# VEHICLE - WARRANTY BULLETIN

BULLETIN 2025-6 | VERSION A

CAMPAIGN N° 2025-0006

## Pulse Rear Central Reflector Replacement

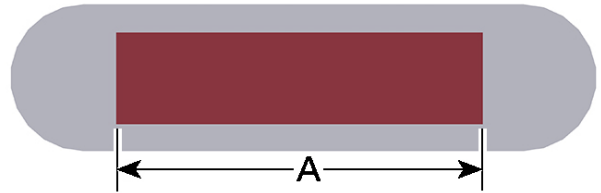
2. Clean the surface to eliminate all glue residues, dust and grease.
3. Cut a 60 mm (2 3/8 in) strip of 3M RP45 VHB™ tape.
4. Peel off the protective liner from the new reflector.
5. Peel off the protective liner only on one side of the 3M RP45 VHB™ tape.
6. Apply the 3M RP45 VHB™ tape centered on the adhesive of the new reflector.

3M recommends the usage of a roller to ensure good contact and to remove air bubbles.

• A = 60 mm (2 3/8 in)

7. Peel off the protective liner on the other side of the 3M RP45 VHB™ tape.
8. Align and firmly install the new reflector. Follow the tape product application instructions to ensure a good bond. 3M recommends to apply a pressure of at least 1 kg/cm<sup>2</sup> (15 PSI) and wait minimum 24 hours before stressing the bond.
